### APPEAL SUMMARY

**Status:** Decision Rendered - Reconsideration of ID 20216

<b>Appeal ID:</b> 20501	<b>Project Address:</b> 151 SW 1st Ave
<b>Hearing Date:</b> 6/12/19	<b>Appellant Name:</b> Milena Di Tomaso
<b>Case No.:</b> B-009	<b>Appellant Phone:</b> 5038632425
<b>Appeal Type:</b> Building	<b>Plans Examiner/Inspector:</b> John Cooley
<b>Project Type:</b> commercial	<b>Stories:</b> 5 <b>Occupancy:</b> B, M ,S <b>Construction Type:</b> 3-A
<b>Building/Business Name:</b> PAE Living Building	<b>Fire Sprinklers:</b> Yes - Throughout
<b>Appeal Involves:</b> Erection of a new structure	<b>LUR or Permit Application No.:</b> 19-142823-LU
<b>Plan Submitted Option:</b> pdf [File 1]	<b>Proposed use:</b> Office, Retail

**BASIS OF DESIGN: USF FAB FIRE RATED FLOOR DOOR, PRODUCT DATA ABOVE.**

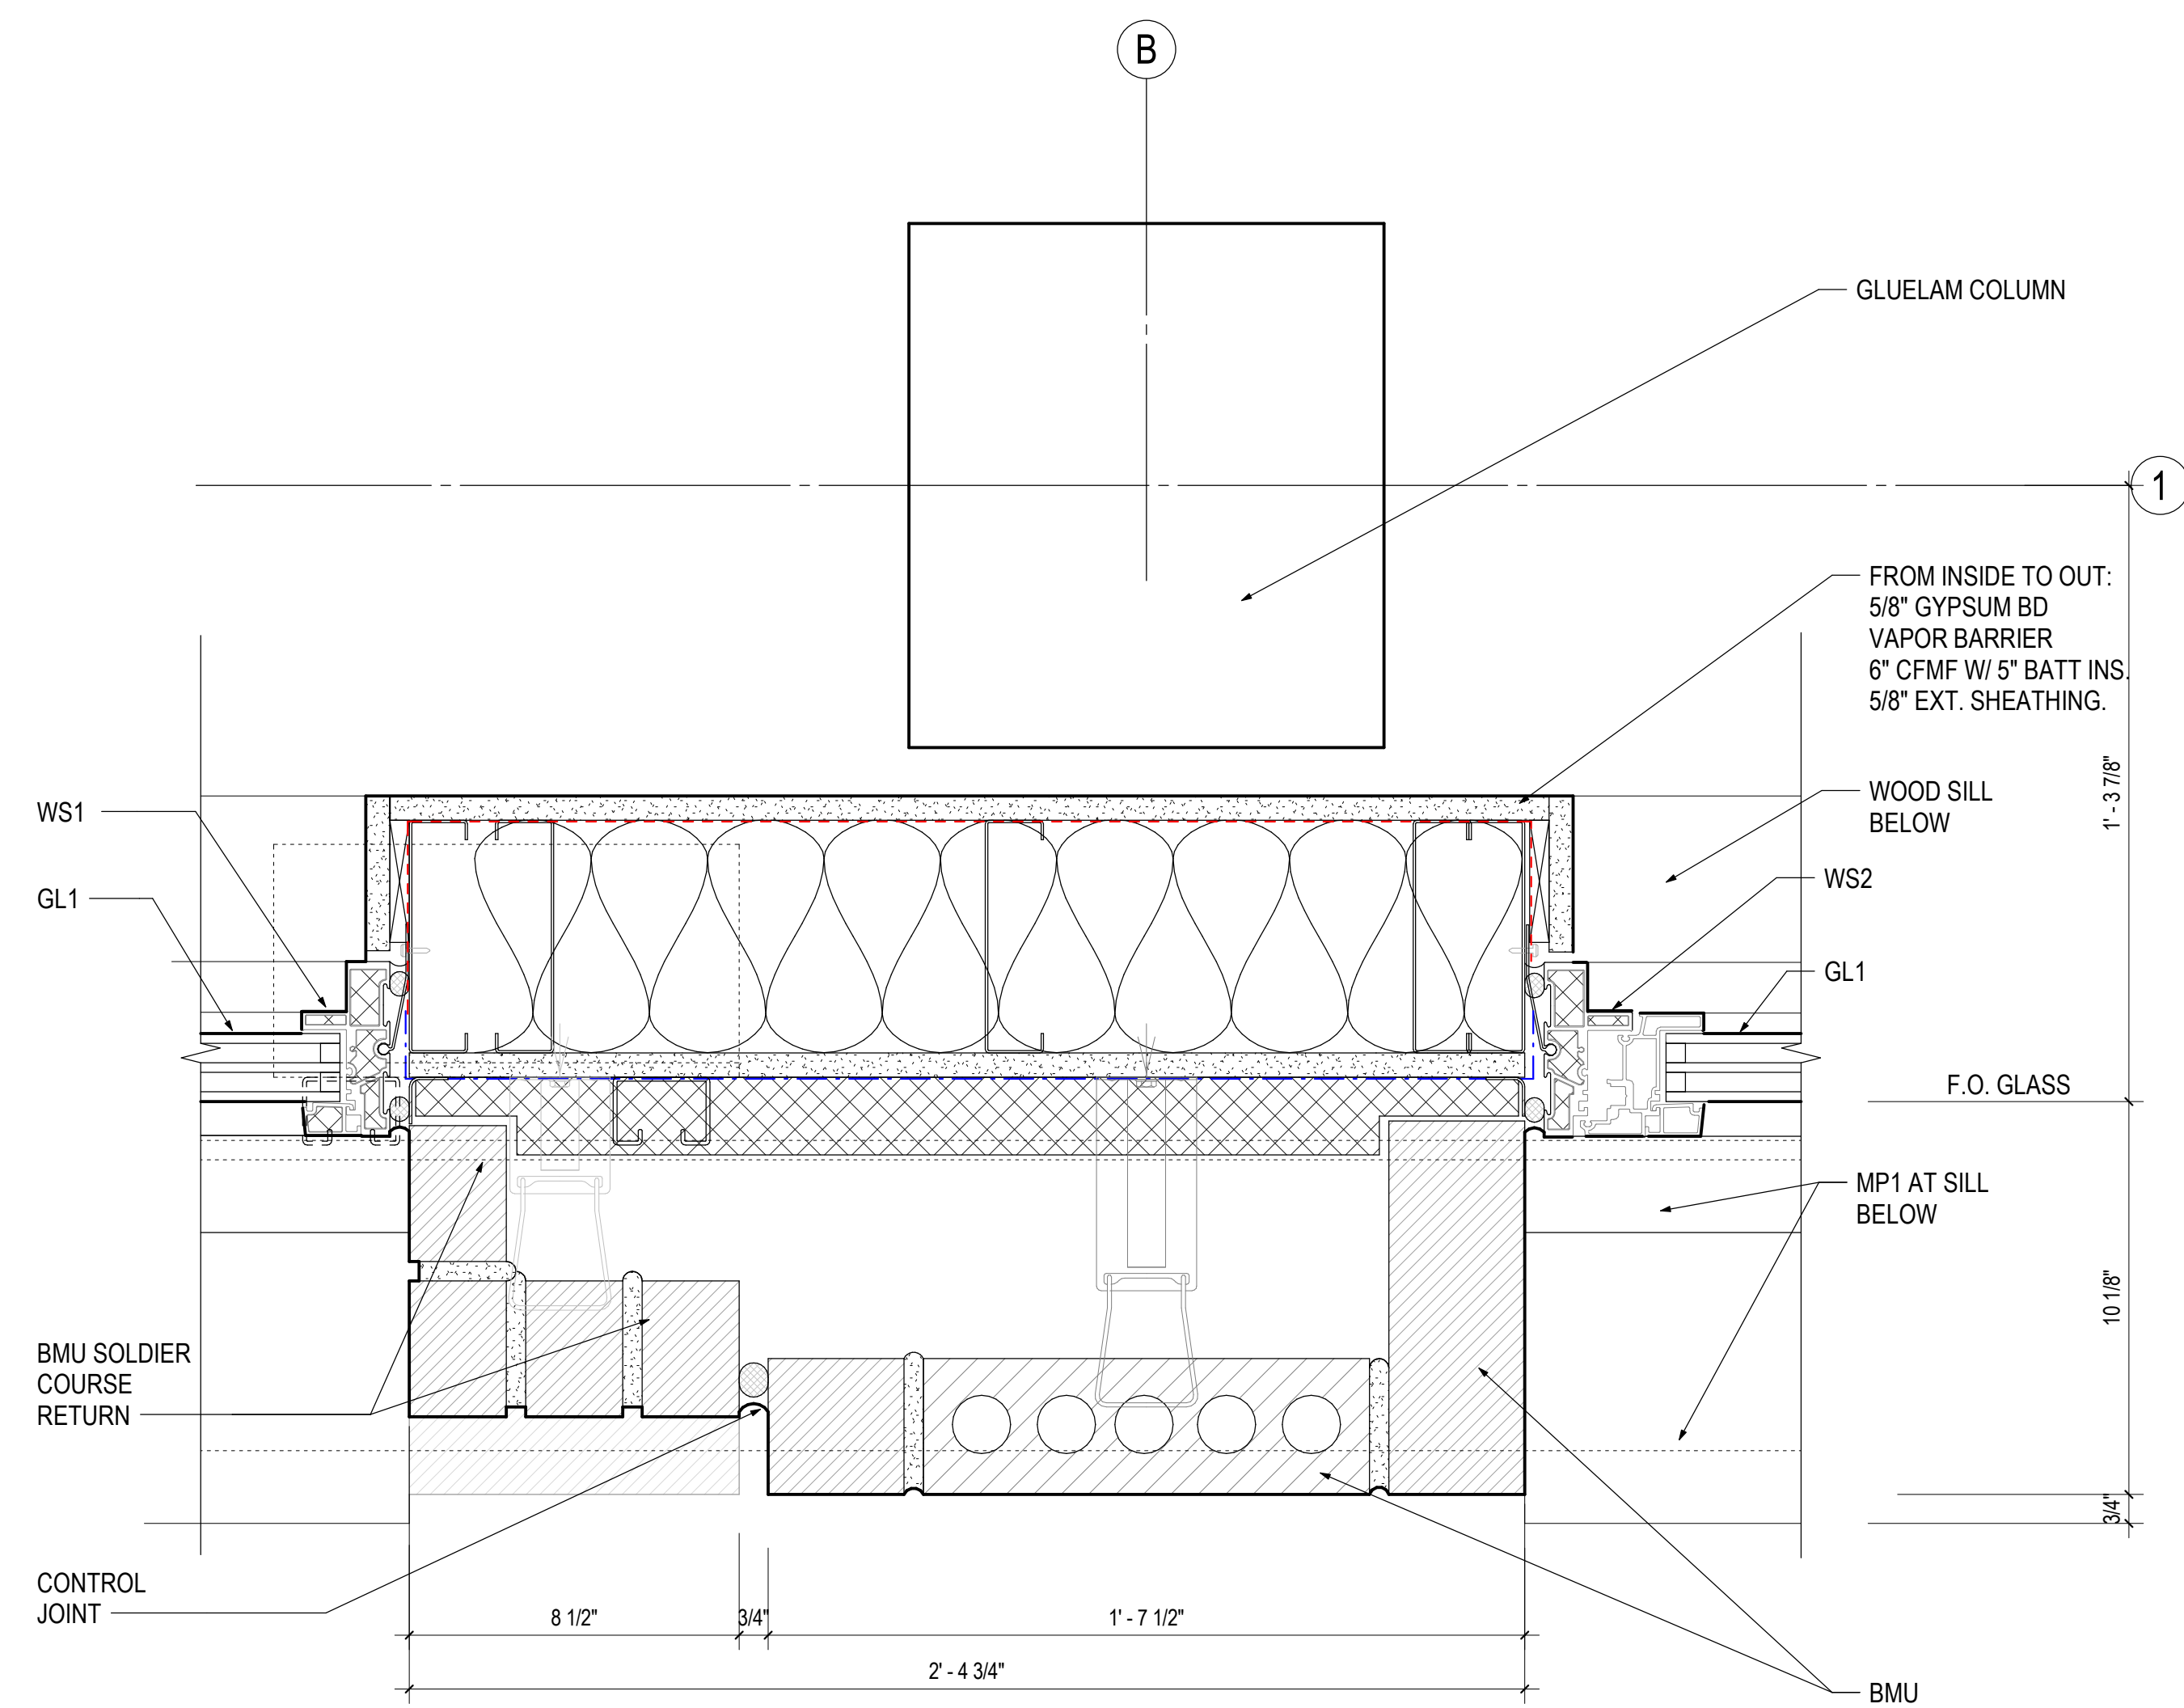
Upon exit from Stair B on the level of exit discharge, the exterior door is readily visible, and a clear and unobstructed path is provided. The building is completely protected throughout with an automatic sprinkler system. Below the lobby is an unoccupied 71,000 gallon rainwater collection cistern constructed of cast in place concrete slab, walls, and ceiling; with no combustible materials present and filled with water. The primary maintenance access to the cistern is located in the mechanical room on the NW corner of the ground floor. A secondary entrance hatch is proposed within the lobby space to provide access to the overflow piping is located within the cistern at that location, primarily to be used in the case of a malfunction of the piping, but not regularly accessed. The floor access hatch is proposed to be fire rated to maintain the 2 hour rating requirement of the stair enclosure, it will be flush mounted with the adjacent floor finish so as not to obstruct the path of egress.

Exception 1.2 is met by maintaining a 2 hour rated separation between the below grade rainwater cistern. The proposed floor hatch will have a 2 hour rating and be flush with adjacent floor finishes.

**4. Second exit through lobby with 2 hour flush mounted access hatch:** Granted as proposed.

TYPICAL SECTION AT EXT. WALL

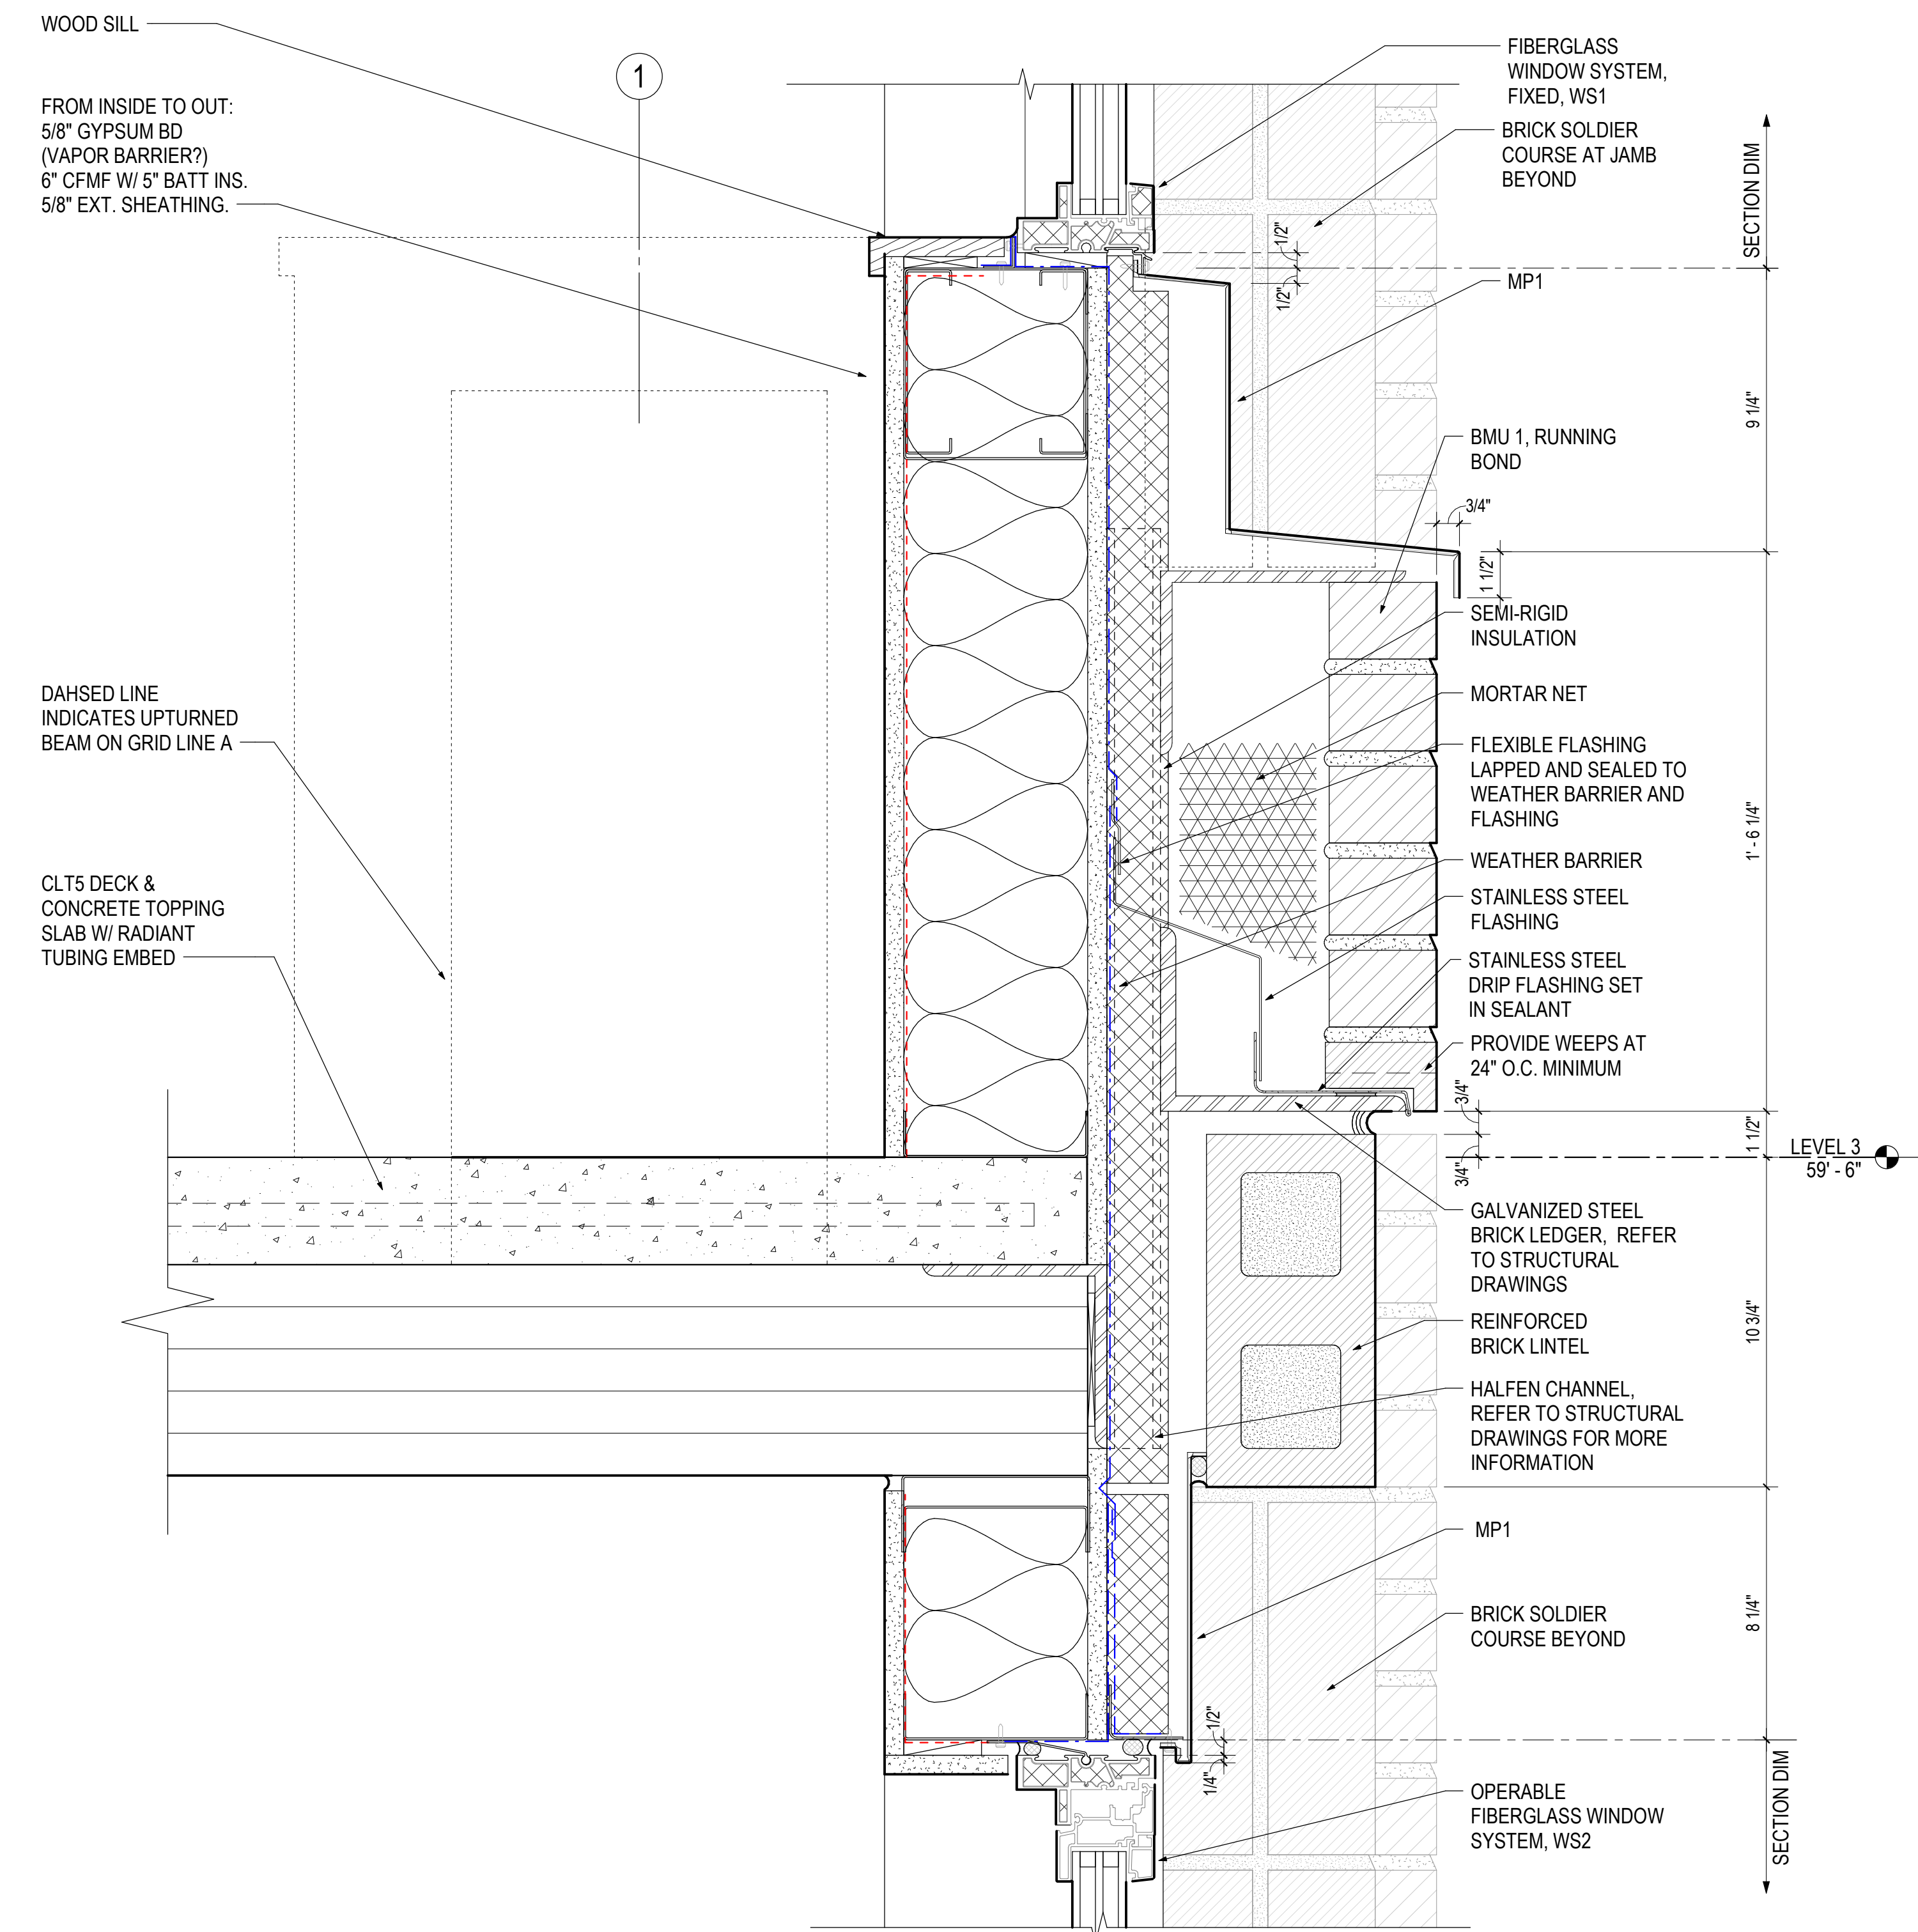
The condition where the CLT panel floor framing intersects with the exterior wall, the concrete continues under the wall framing. A 12" long 6"x6" steel angle attaches to the edge of the CLT panel every 7'-6" along the full length of the façade, which supports the ledger angle for the brick veneer. Where the angle does not exist, 5/8" gypsum sheathing extends in front of the edge of the CLT panel. The CLT panel is completely encapsulated within the exterior wall with concrete slab on top, either metal angle or 5/8" gypsum sheathing on the exterior edge, and metal framing with rockwool insulation at the underside. At locations where a wall rating is required, the exterior wall will be sealed to the floor structure.

**Reason for alternative** Per 602.3, combustible material is prohibited within the exterior walls. The Cross-laminated timber floor panels are wood and by code, viewed as a combustible material. This section allows the use of wood if it is Fire-retardant treated per section 2303.2, though the CLT panels are too large to be fire-retardant treated, and thus an alternate solution is required to protect the CLT panel in the wall assembly.

Using Item #2 and #3, the exterior surface of the edge of the CLT panel will be protected by a non-combustible material (steel framing and concrete) on the top and bottom, and gypsum board at the side; therefore protecting each edge of the panel within the exterior wall.

**3. Combustible material within Type III exterior non-bearing walls:** Granted provided Code Guide Condition #17 details are verified as part of permit plan review.
